Product/Process
Change
Notification
PCN08044

Product:	PCIe	Part Numbers Concerned:	See attached list
Product Manager:	Alan Lo		Issue Date: March 28, 2008
			Page(s): 1/3
Distribution:	GLOBAL

Subject
Product Design Change

Removing the metal clip from the post

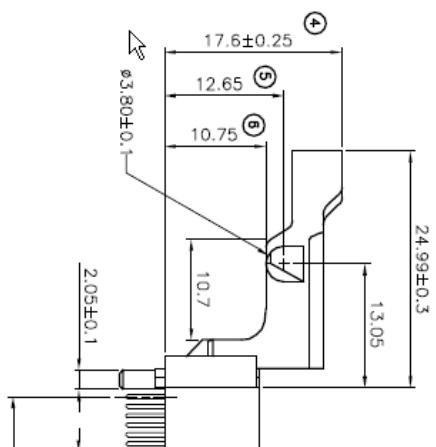
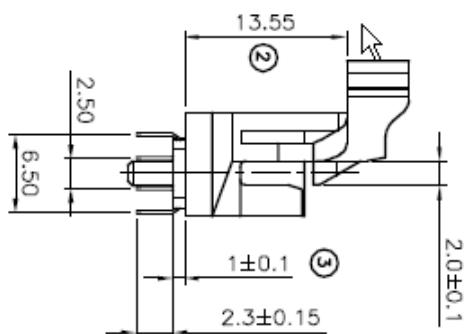
W/ CLIP
CHANGE BEFORE

WO/ CLIP
CHANGE AFTER

Dimension and Apparel changes

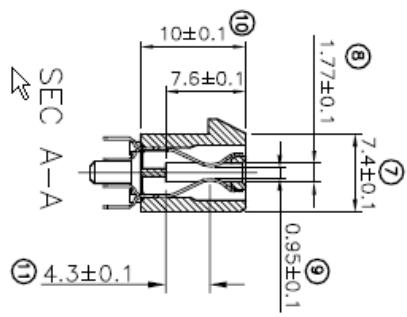
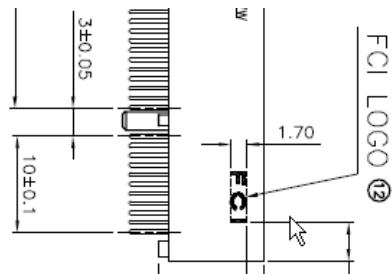
Location#	Before	After
1	1.7+/-0.1	1.78+/-0.1
2	13.75	13.55
3	0.8+/-0.1	1.0+/-0.1

4	17.8+/-0.25	17.6+/-0.25
5	12.85	12.65
6	10.95	10.75

7	7.2+/-0.1	7.4+/-0.1
8	1.85+/-0.1	1.77+/-0.1
9	0.8+/-0.1	0.95+/-0.1
10	10.2+/-0.1	10.0+/-0.1
11	4.4+/-0.1	4.3+/-0.1
12	Areva	FCI
